Subject: Modification of the Approved Groundwater Remedy for the Plant Site at the Colstrip Steam Electric Station in Colstrip, Montana

Geosyntec Consultants, Inc. (Geosyntec) on behalf of Talen Montana, LLC (Talen Montana) has prepared this letter to request a modification of the approved groundwater remedy for the Plant Site at the Colstrip Steam Electric Station (CSES) in Colstrip, Montana.

DATE: June 29, 2023 **PROJECT NO.** 350.0064.005
TO: Carrie Pendleton -Geosyntec
CC: Gordon Criswell and Jennifer Petritz – Talen Energy
FROM: Amelia Tallman, Derek Goble - NewFields
SUBJECT: Plant Site Closure Remedy Modification Modeling

ALTERNATIVE 4B STAGE 1

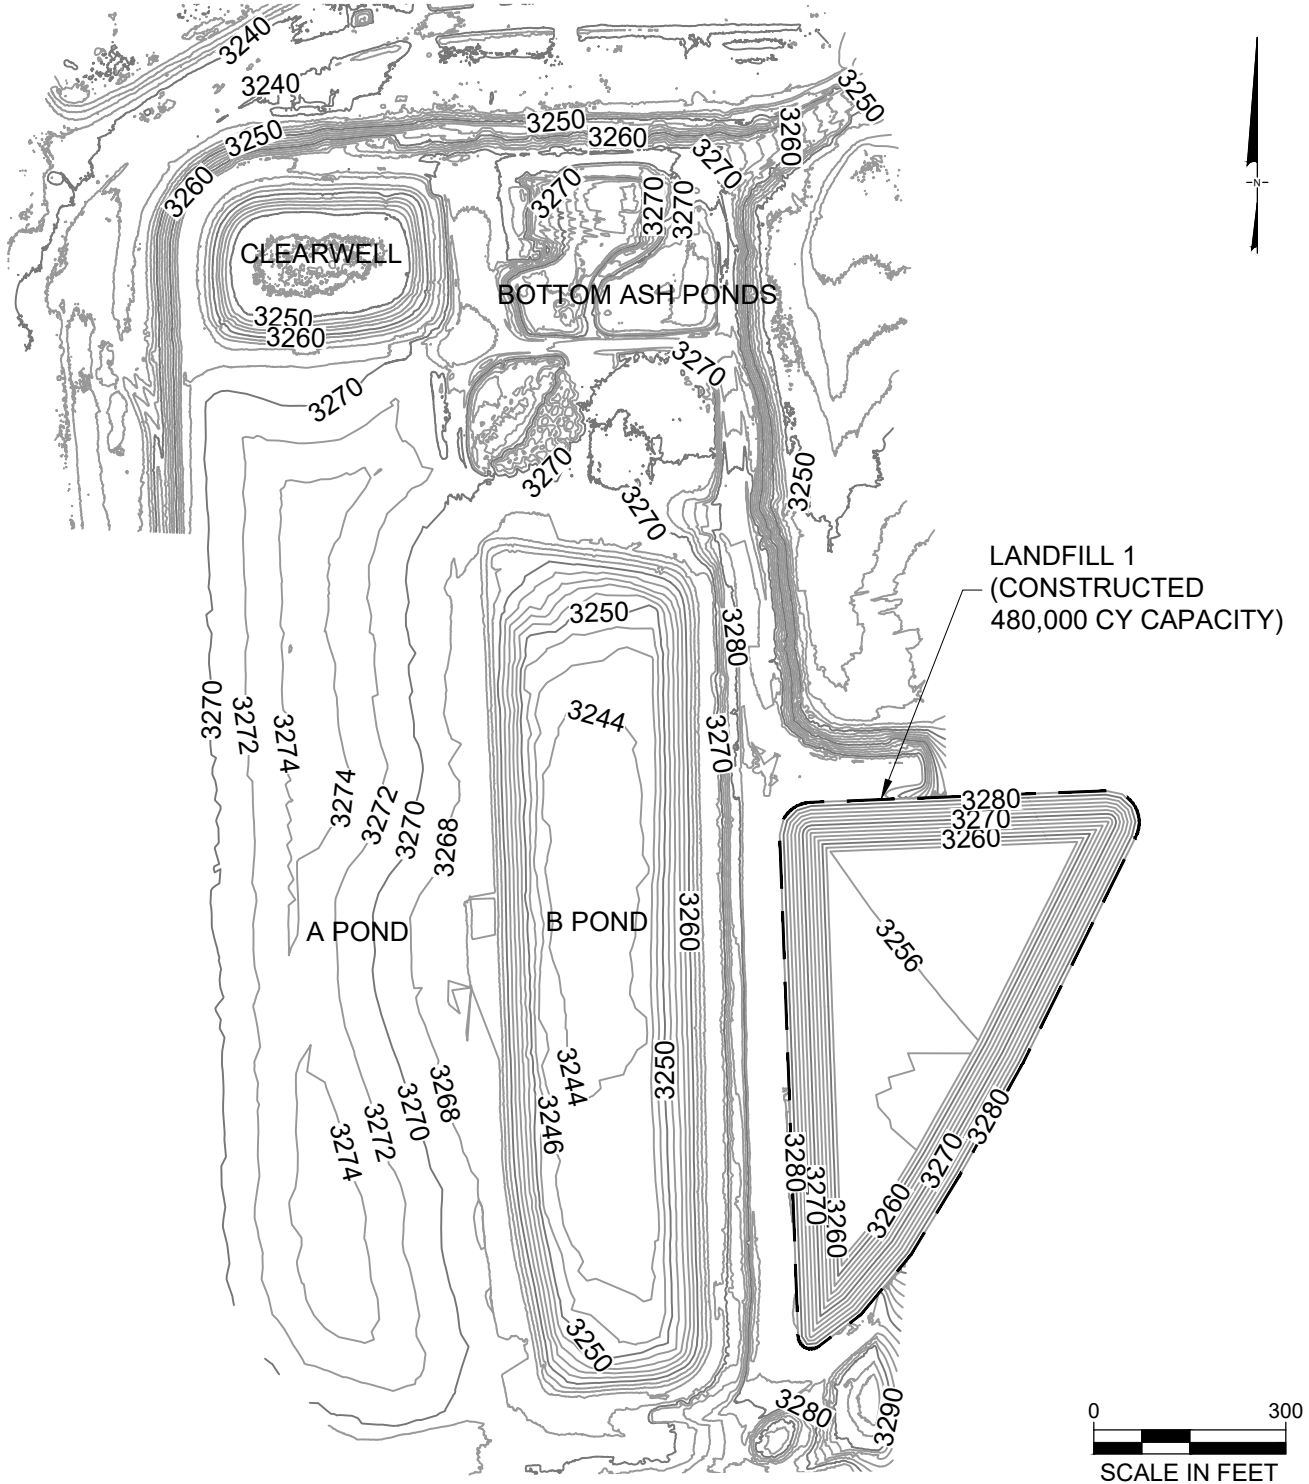
As sequencing is important in this alternative, construction is proposed to take place in stages. In Stage 1 (**Figure 2**), Landfill 1 would be constructed at the site. In Stage 2 (**Figure 3**), CCR removal would begin at the Units 1 & 2 Bottom Ash Ponds and Clearwell and progress south until Landfill 1 has been filled. In Stage 3 (**Figure 4**), as the Units 1 & 2 Bottom Ash Ponds and Clearwell area is cleared of CCR and affected soil, the construction of Landfill 2 would begin at the location of the Units 1 & 2 Bottom Ash Ponds and Clearwell. By constructing Landfill 2 in cells, additional disposal capacity would be added. In Stage 4 (**Figure 5**), the CCR removal progresses further south until all CCR has been removed from the existing U12 impoundments area and placed in Landfill 2. Landfills 1 and 2 would be closed upon reaching capacity or the final removal of CCR. Remaining areas not occupied by Landfill 2 would be reclaimed.

1. UNDER STAGE 1, LANDFILL 1 IS CONSTRUCTED.
2. ASH REMAINS IN ALL PORTIONS OF THE BOTTOM ASH PONDS, A POND, AND B POND.

ALTERNATIVE 4B STAGE 2	
PLANT SITE U12 IMPOUNDMENTS COLSTRIP, MONTANA	
PROJECT NO: ME1343I	MAY 2023
FIGURE 3

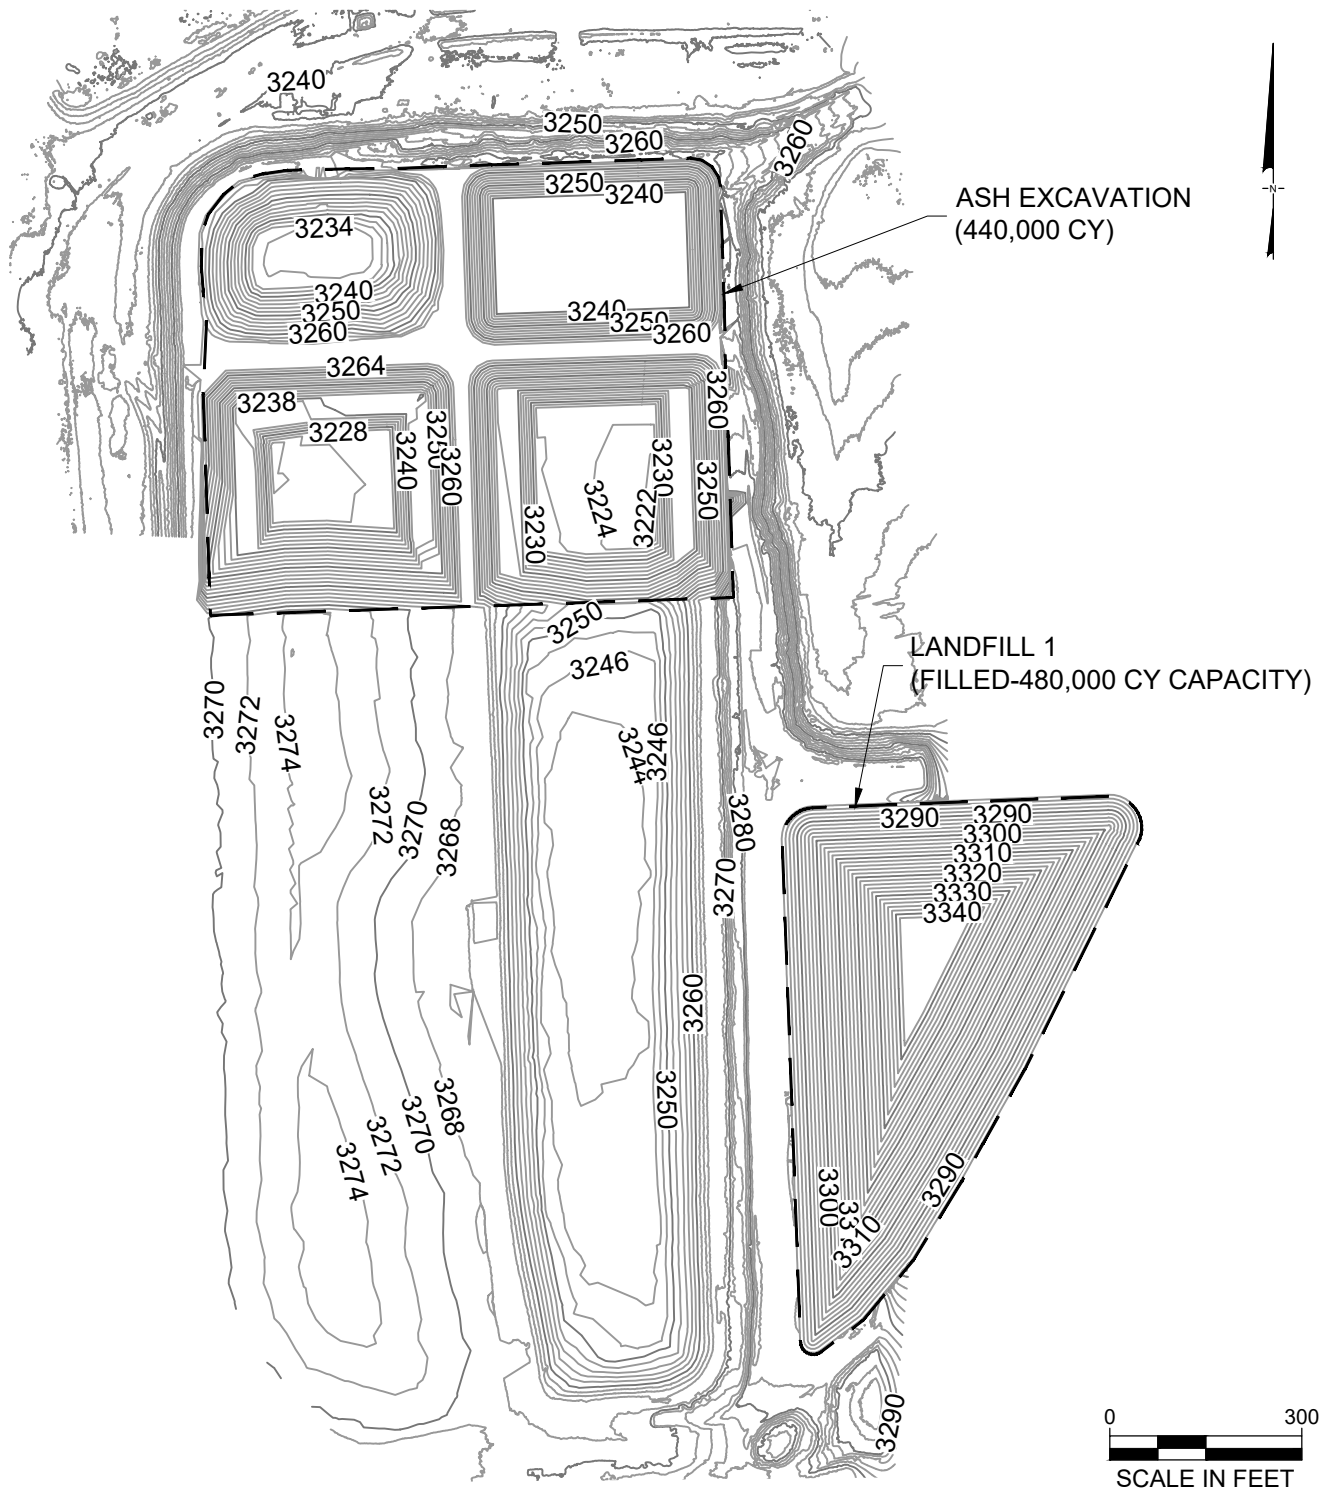
- NOTES:
1. LANDFILL 1 WAS PREVIOUSLY CONSTRUCTED UNDER STAGE 1.
 2. UNDER STAGE 2, ASH IS EXCAVATED FROM THE BOTTOM ASH PONDS AND CLEARWELL AND THE NORTHERN PORTIONS OF A AND B PONDS AND PLACED IN LANDFILL 1.
 3. ASH REMAINS IN THE SOUTHERN PORTIONS OF A AND B PONDS.

ALTERNATIVE 4B STAGE 3

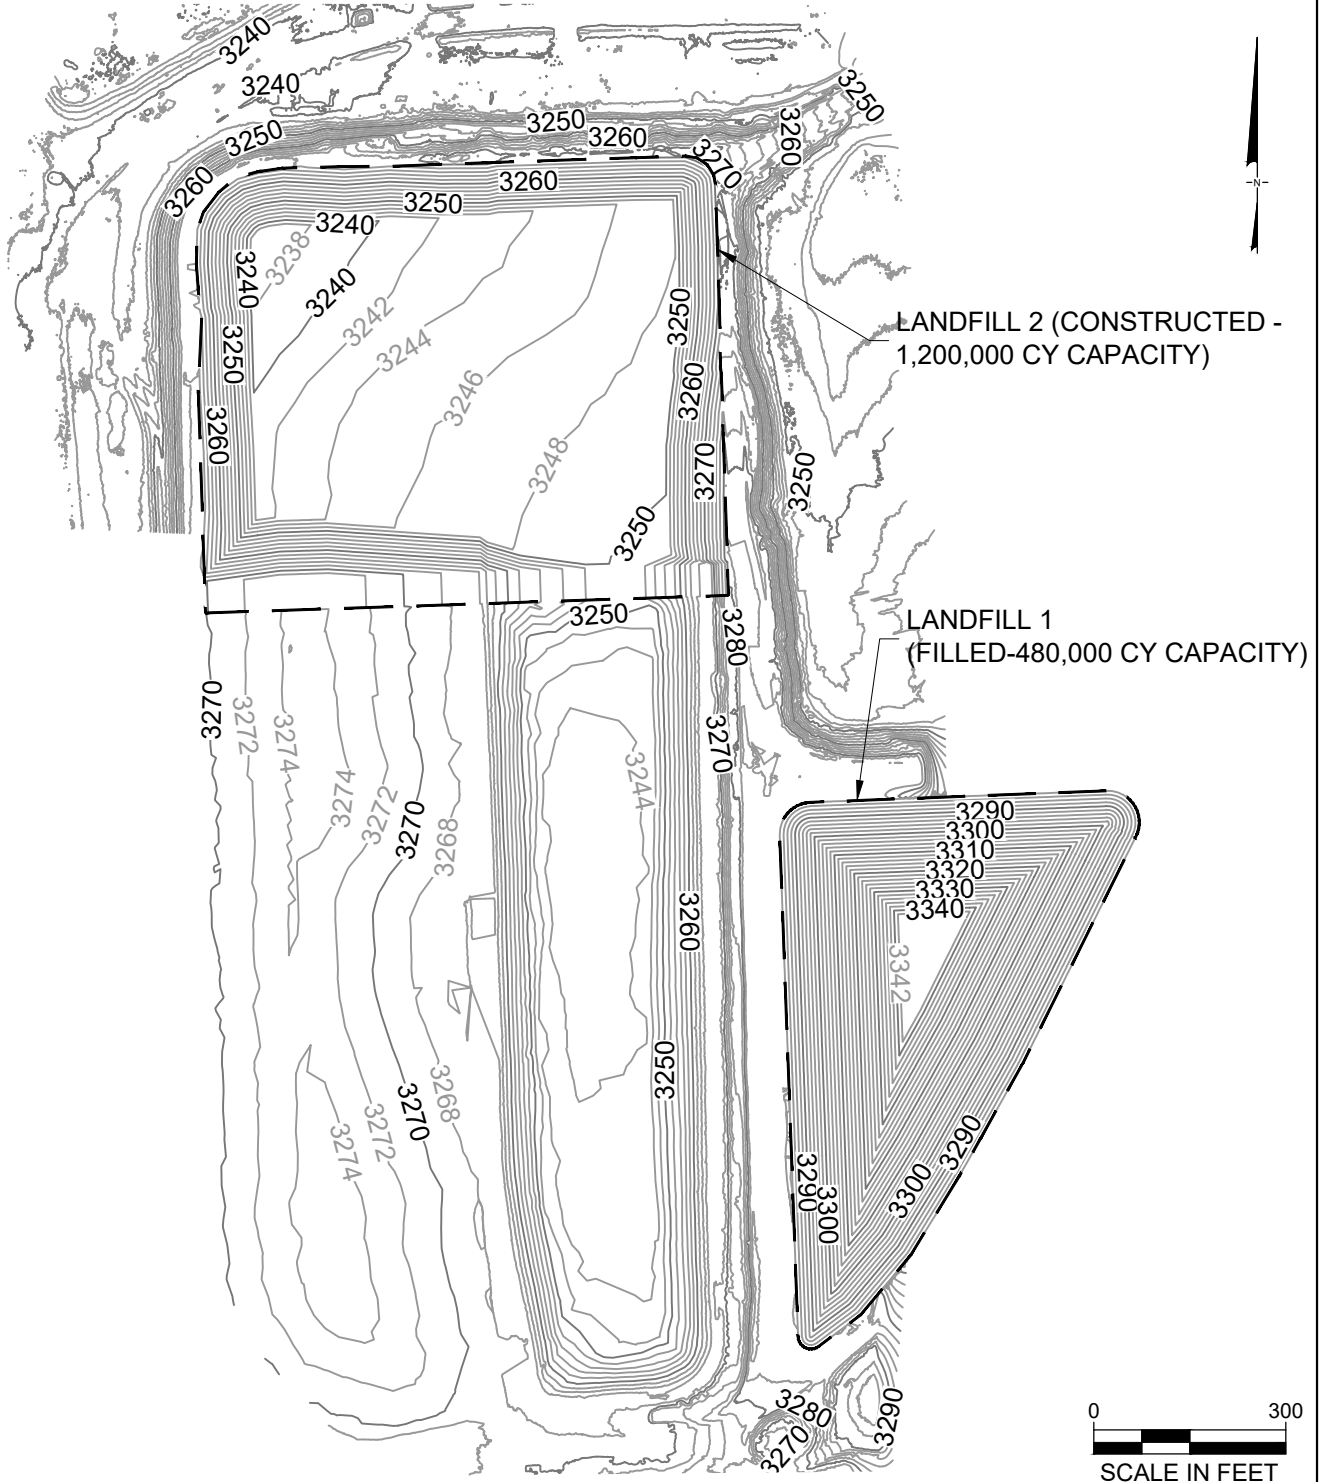
1. LANDFILL 1 WAS PREVIOUSLY CONSTRUCTED UNDER STAGE 1 AND FILLED UNDER STAGE 2 WITH ASH FROM THE BOTTOM ASH PONDS AND CLEARWELL AND THE NORTHERN PORTIONS OF A AND B PONDS.
2. UNDER STAGE 3, LANDFILL 2 IS CONSTRUCTED.
3. ASH REMAINS IN THE SOUTHERN PORTIONS OF A AND B PONDS.

ALTERNATIVE 4B STAGE 4

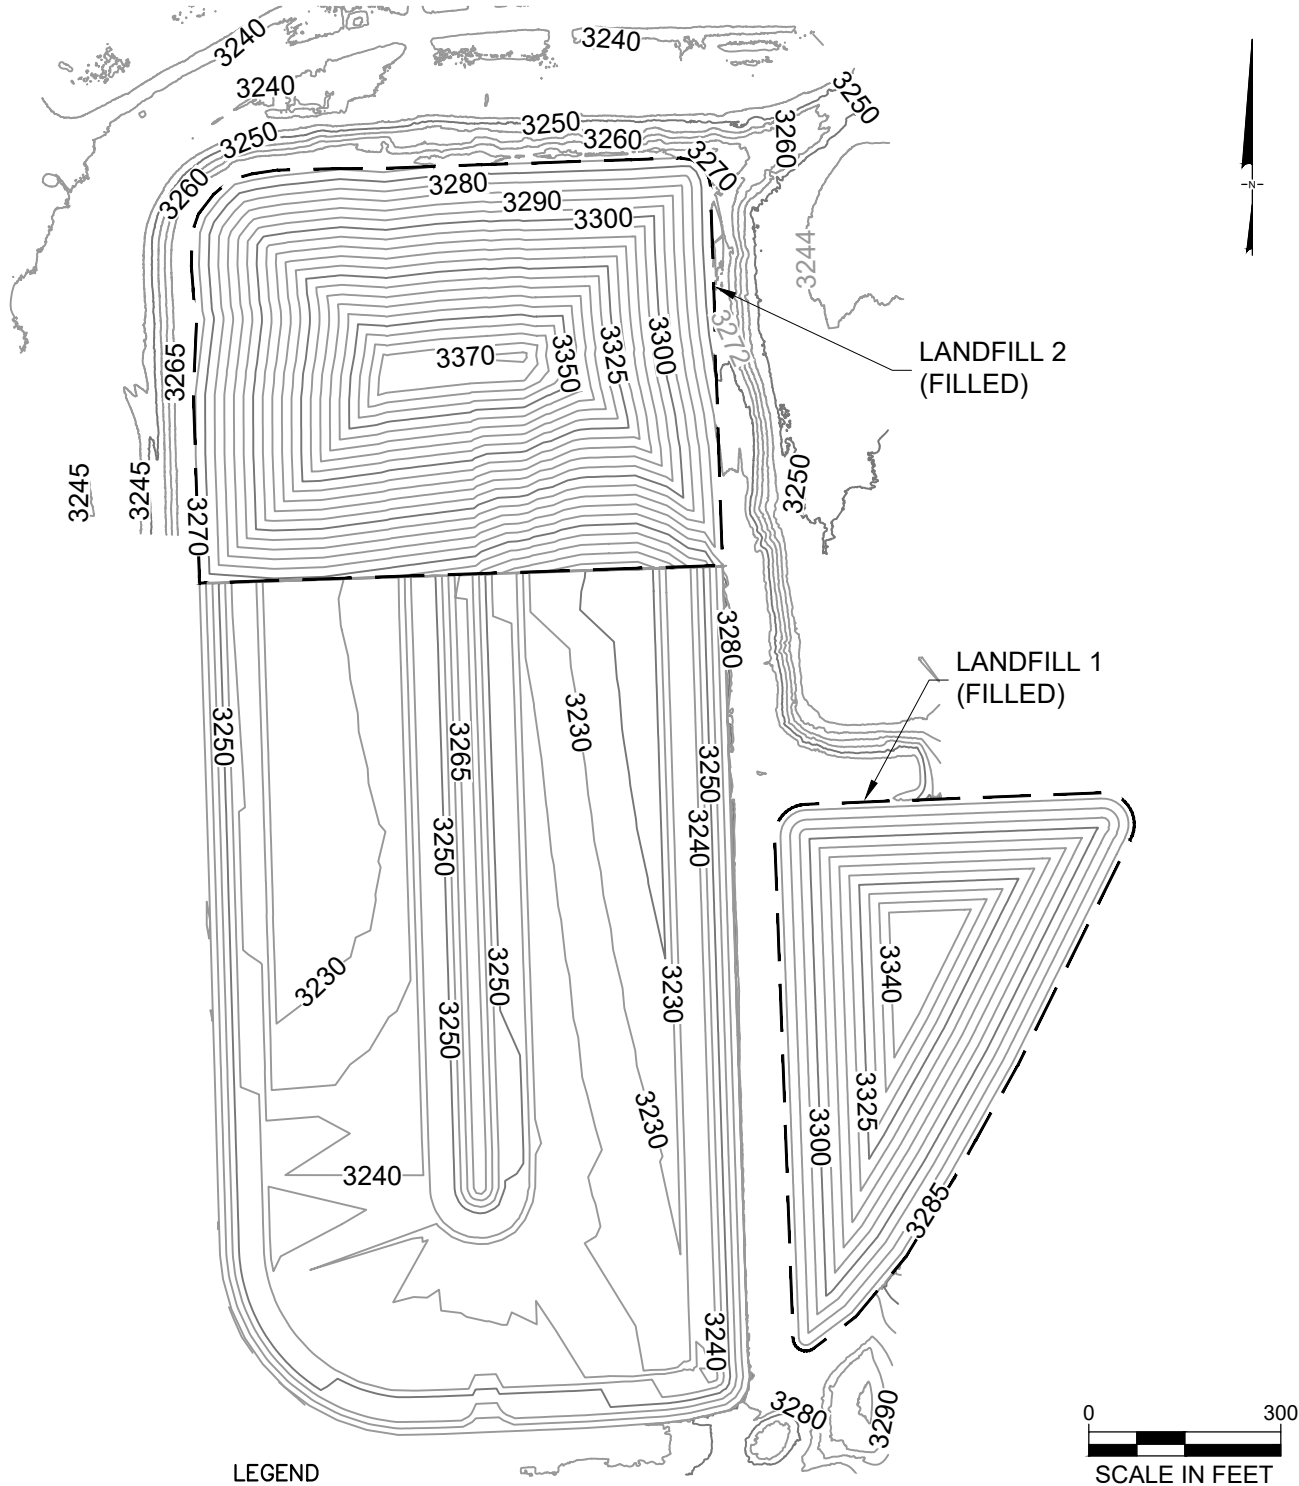
1. LANDFILL 1 WAS PREVIOUSLY CONSTRUCTED UNDER STAGE 1 AND FILLED UNDER STAGE 2 WITH ASH FROM THE BOTTOM ASH PONDS, CLEARWELL AND THE NORTHERN PORTIONS OF A AND B PONDS.
2. LANDFILL 2 WAS PREVIOUSLY CONSTRUCTED UNDER STAGE 3.
3. UNDER STAGE 4, LANDFILL 2 IS FILLED WITH ASH FROM THE SOUTHERN PORTIONS OF A AND B PONDS. ALL ASH IS NOW IN LANDFILLS 1 AND 2.
4. THE SOUTHERN PORTION OF A AND B PONDS WILL BE SUBSEQUENTLY RESTORED.

FIGURE
6

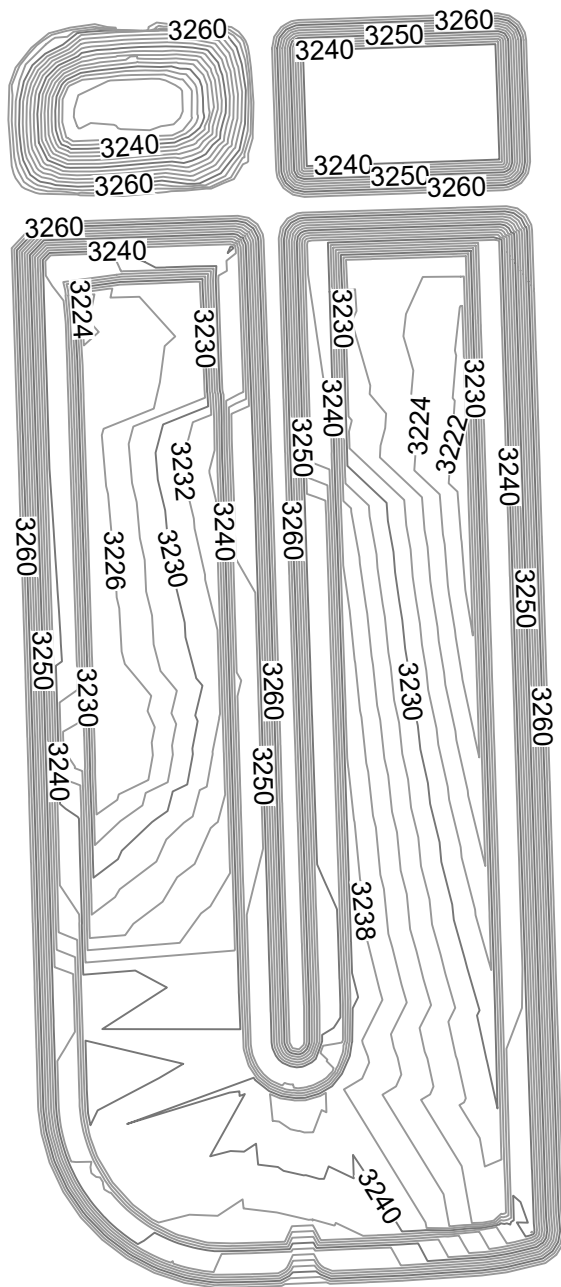
As the base grades of CCR (shown in **Figure 6**) are only best estimates, if CCR is found to be past the base grades, horizontally or vertically, CCR removal would continue in the associated direction to remove any visible CCR.
